[REDACTED]
Foreshore Unit,
Department of Housing, Local Government and Heritage,
Newtown Road,
Co. Wexford
8th March 2022

Environmental Report with Statutory Declarations

Re: FS007083 – Eirgrid to lay four submarine electricity cables across the Shannon Estuary between Co. Kerry and Co. Clare.

Applicant: EirGrid

Drawing Number
229379408-MMD-01-XX-DR-E-1121

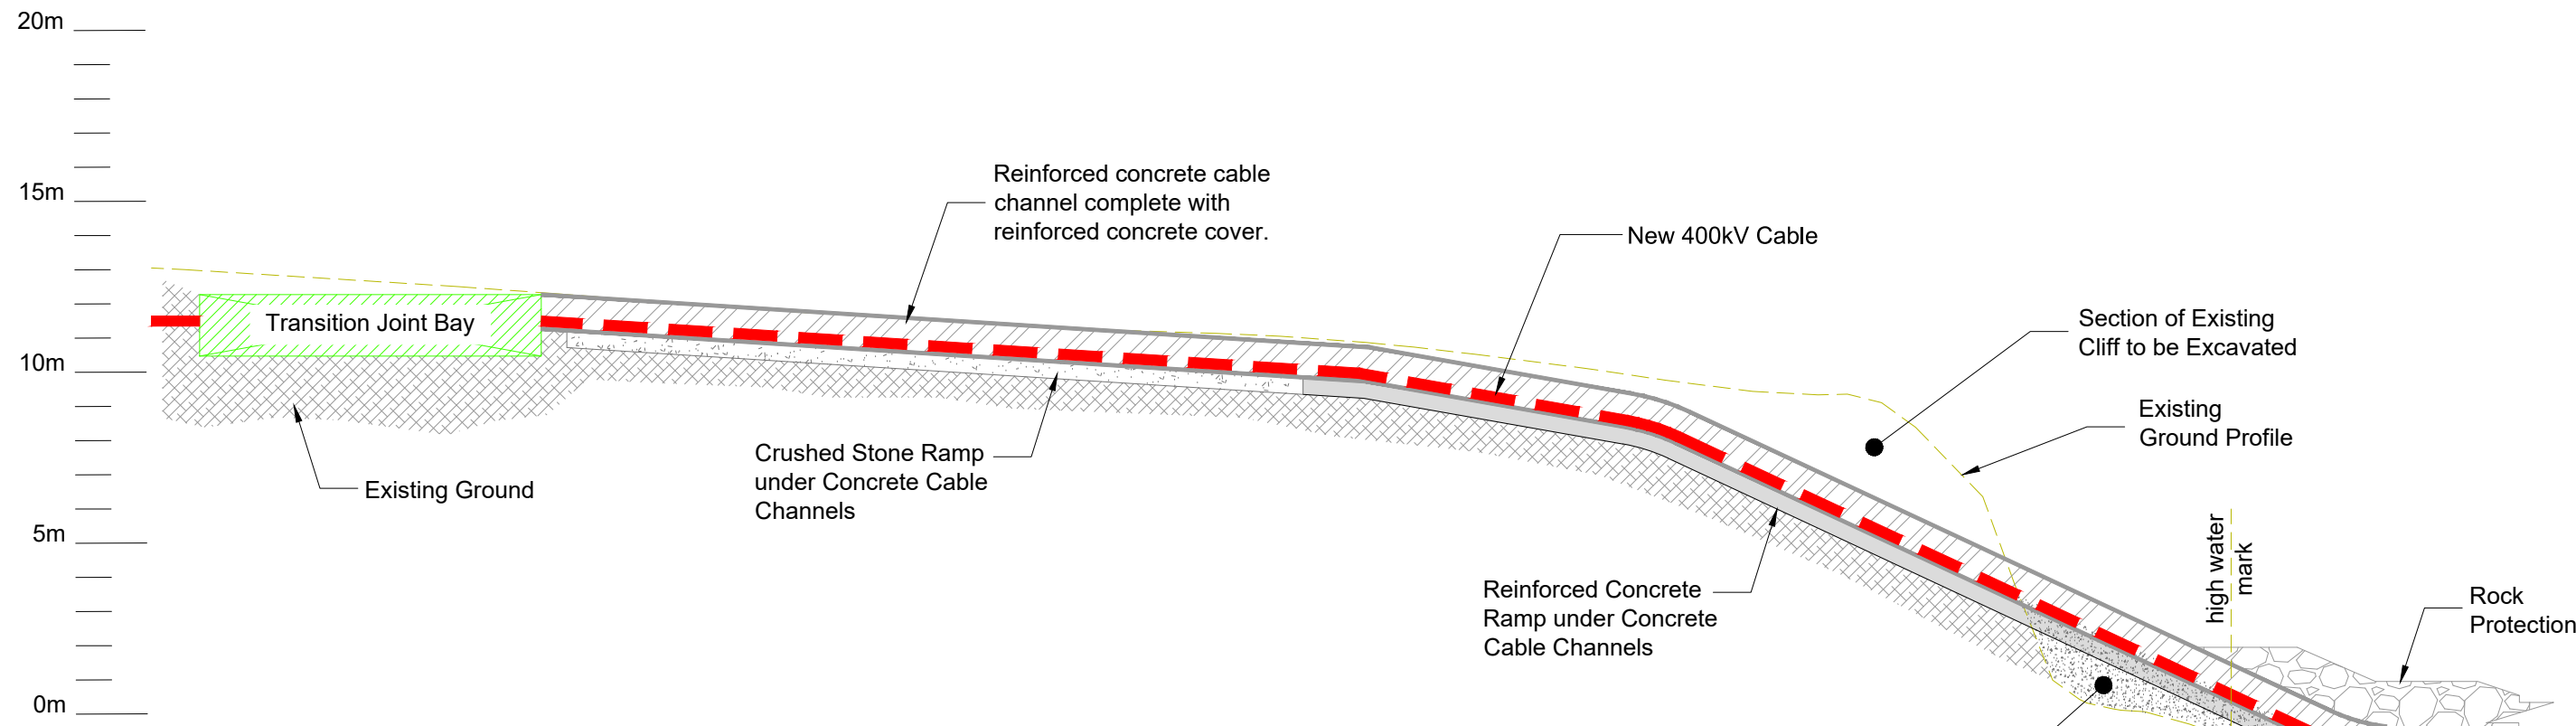
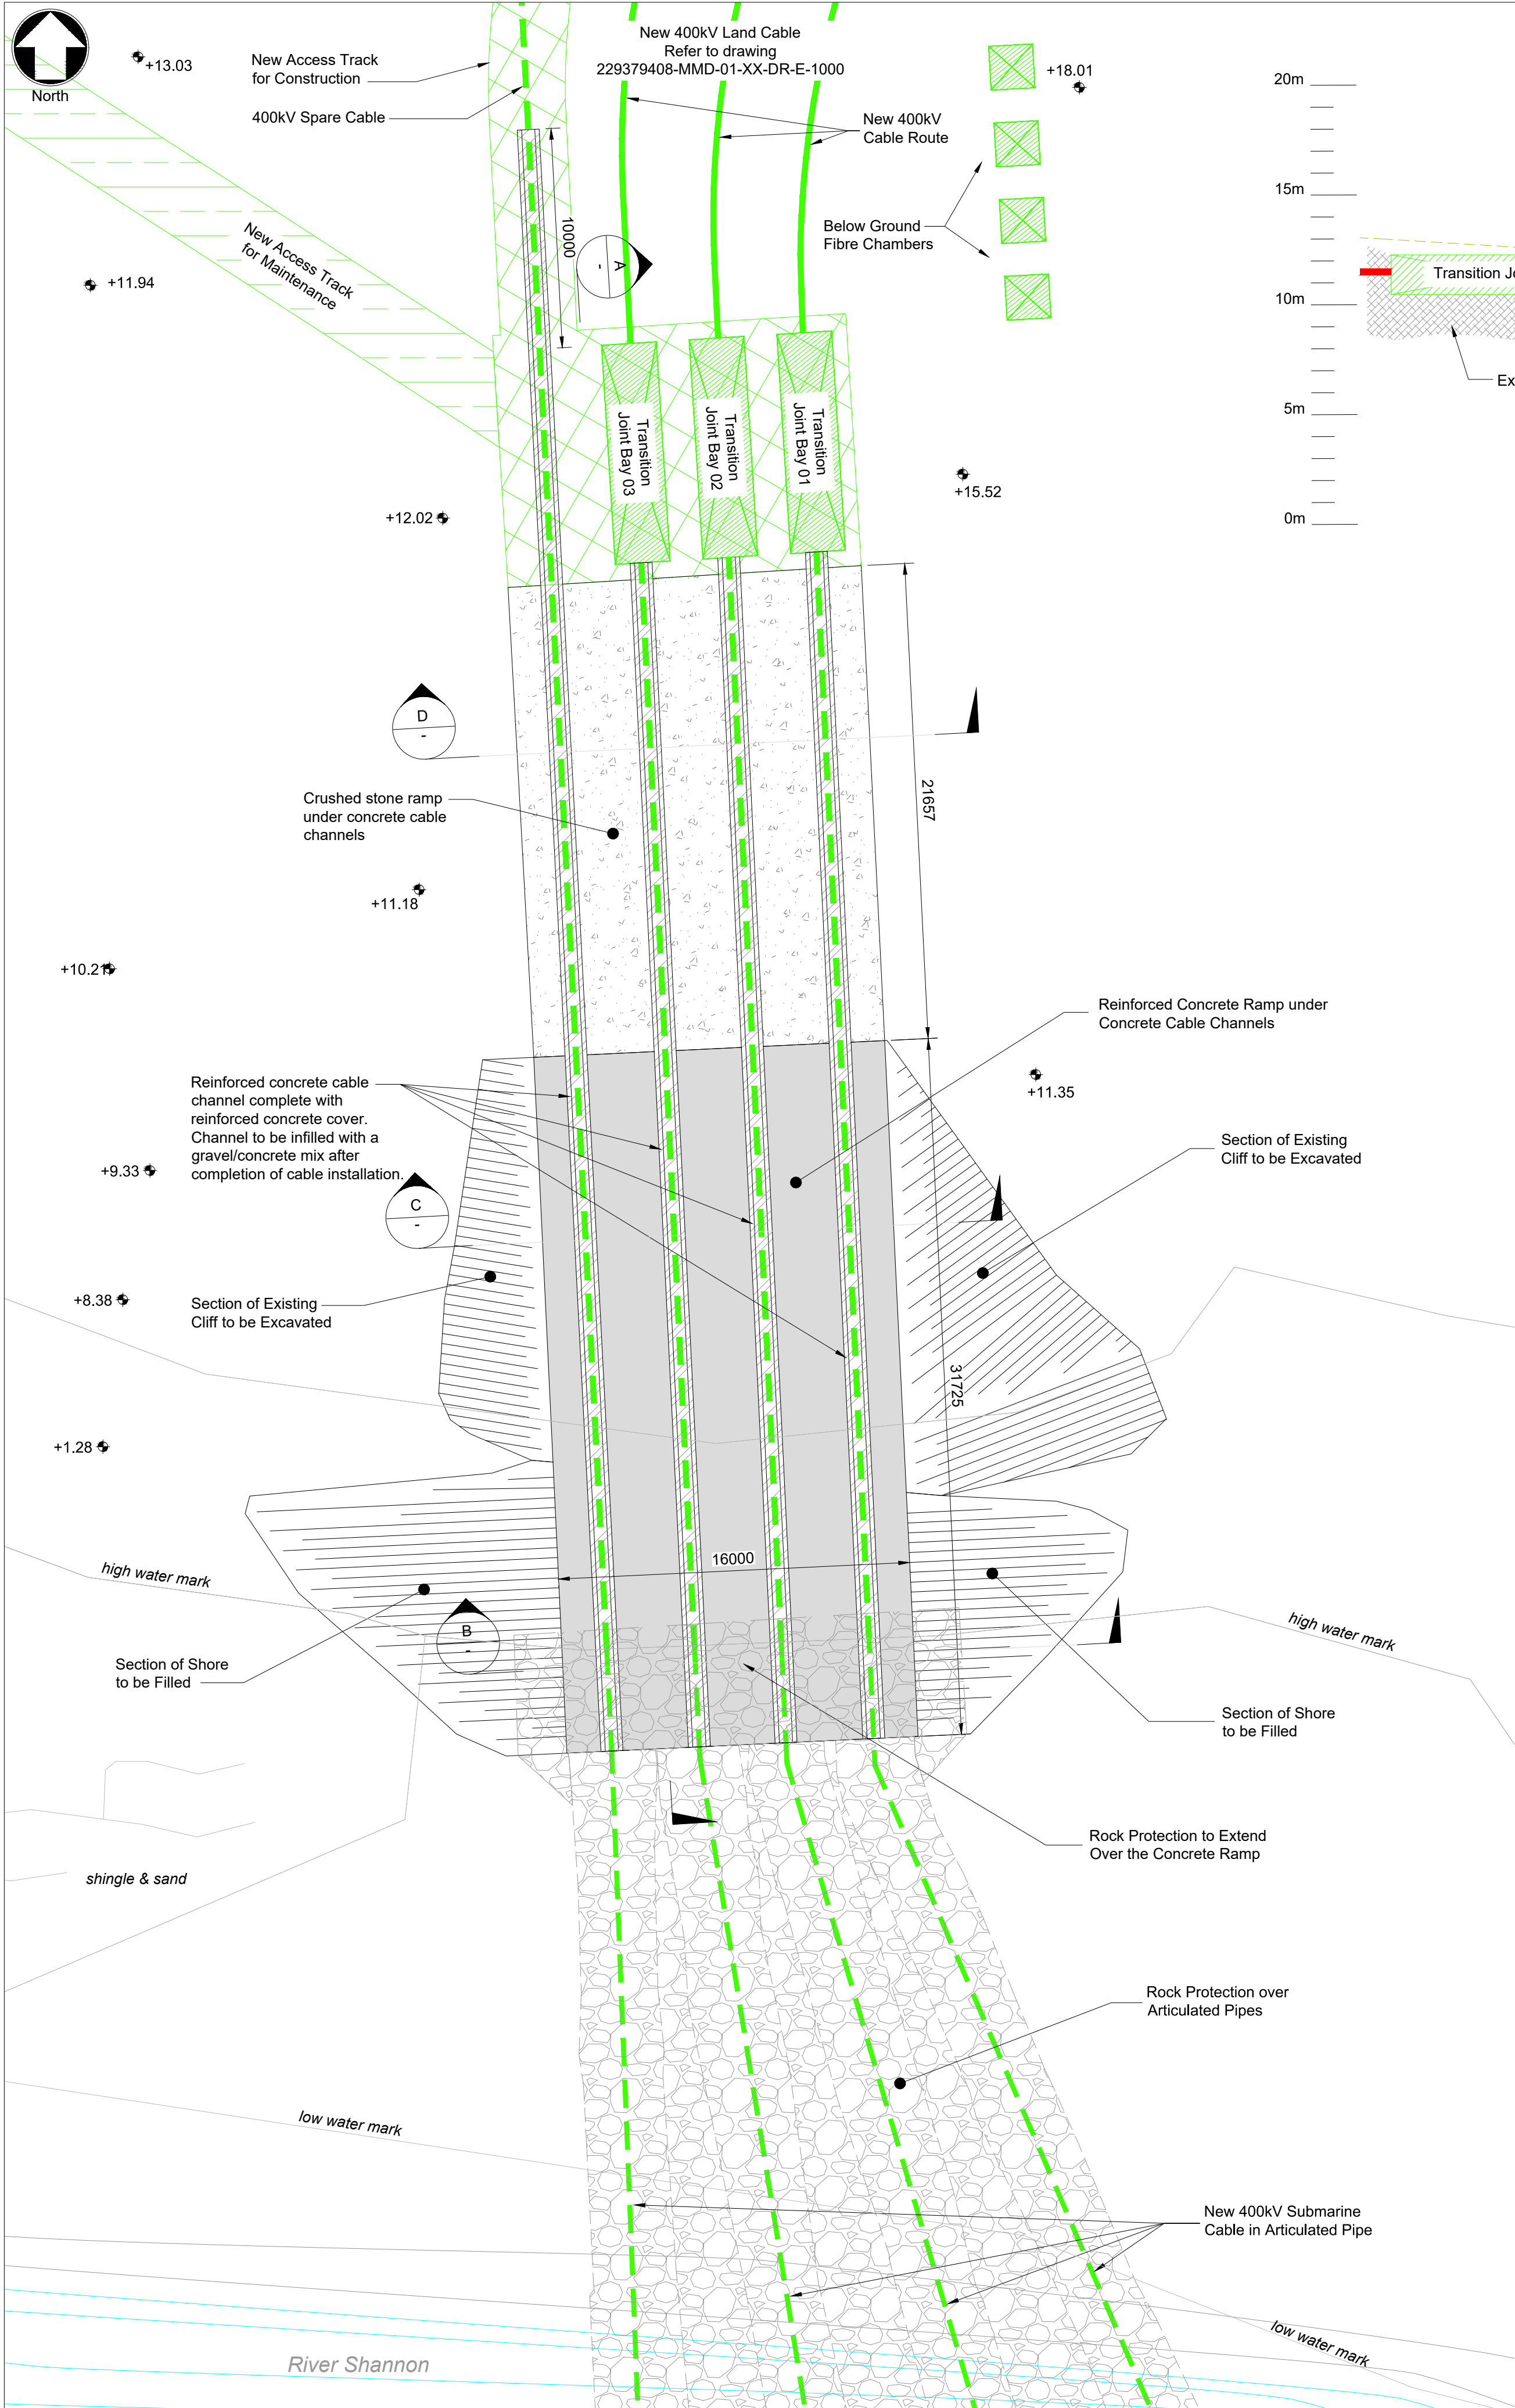
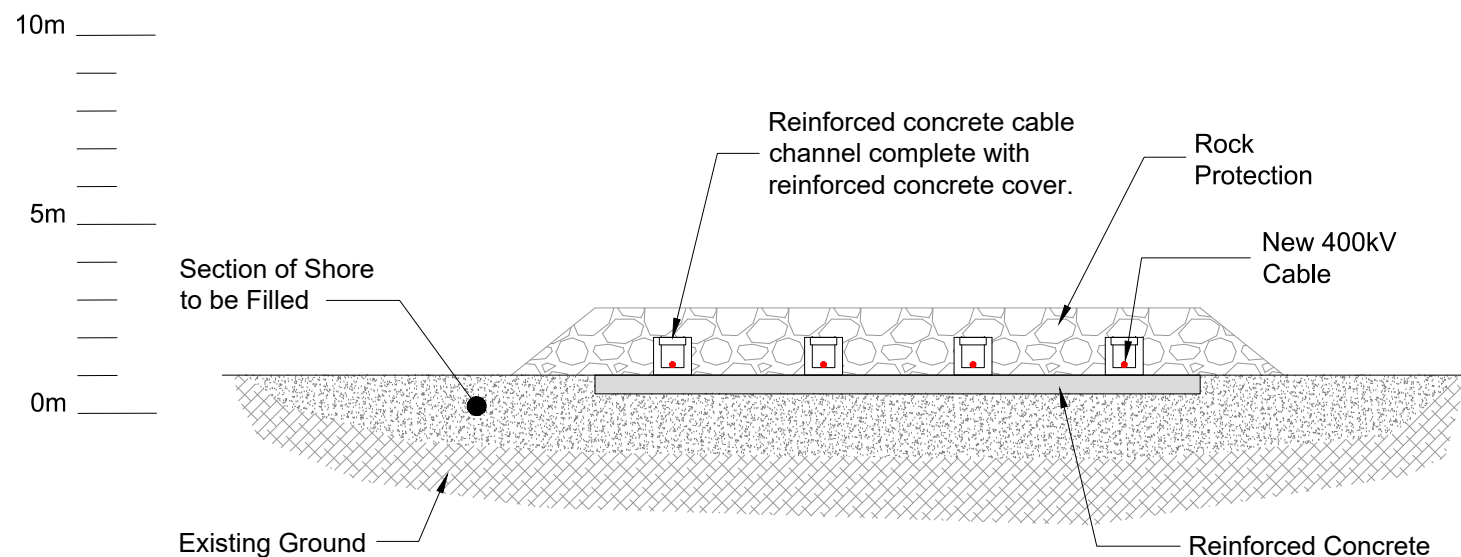
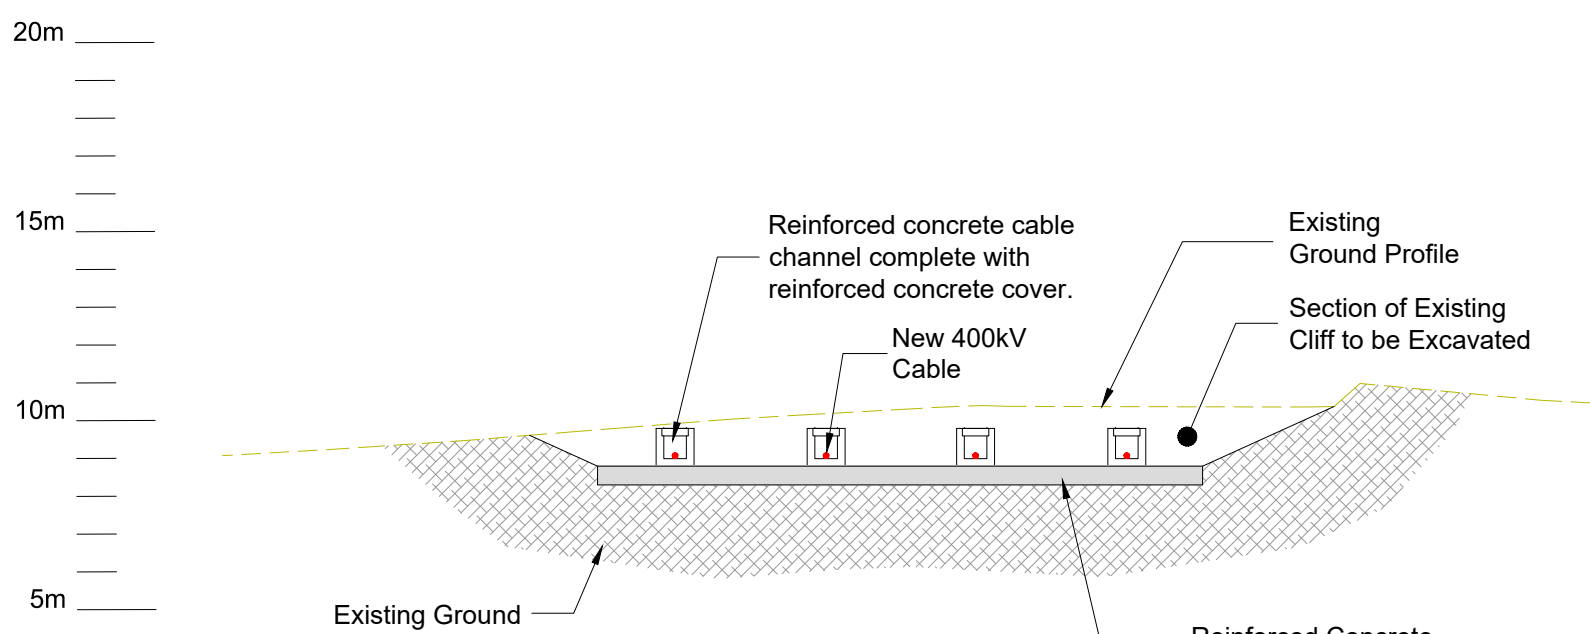
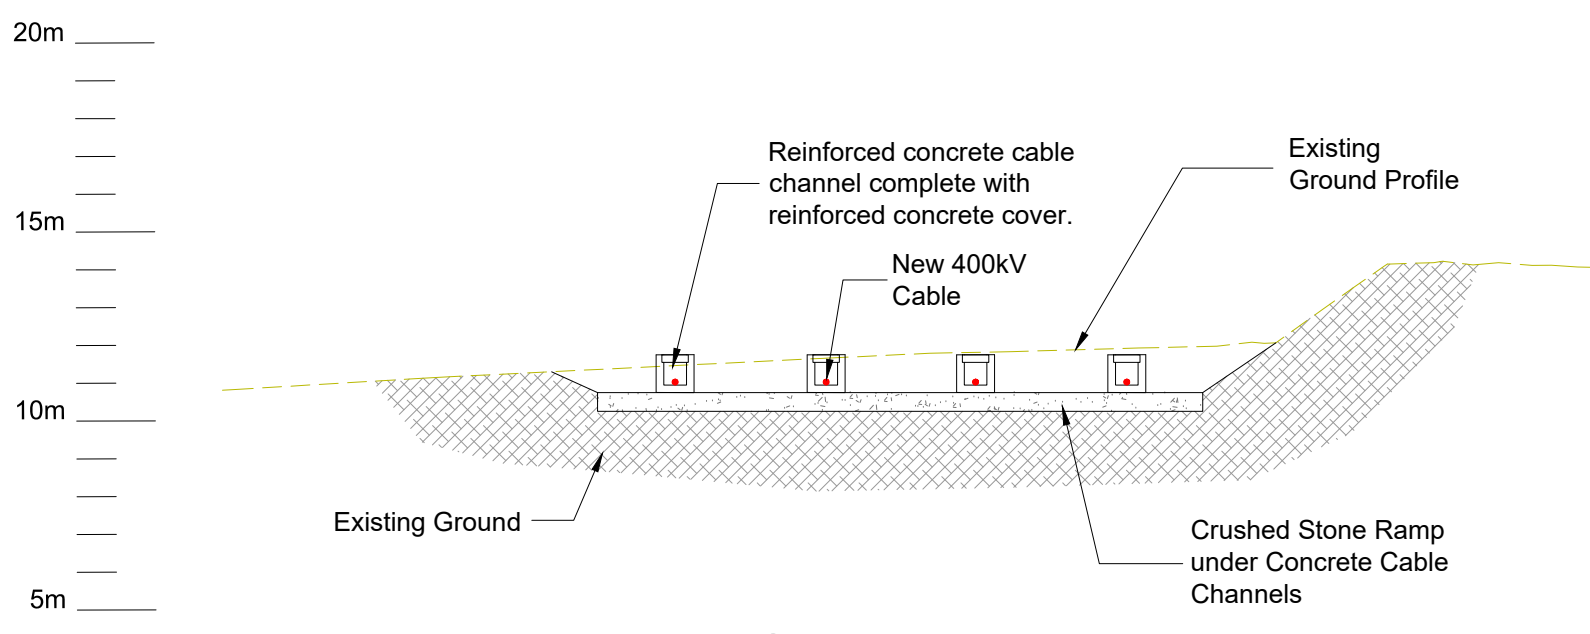
5. *Provide an estimation of the area of rock armour to be used to protect the cables on the bed of the Estuary.*

Rock armour is required on either side of the estuary to enhance cable protection at the near shore locations to manage the risk of shoreline erosion from wave action. The provision of rock armour is addressed in the Planning and Environment Considerations Report (PECR) accompanying the application. Typical plan layout and sections of the proposed rock armour is shown on drawing numbers 229379408-MMD-01-XX-DR-E-1121 and 229379408-MMD-01-XX-DR-E-1120.
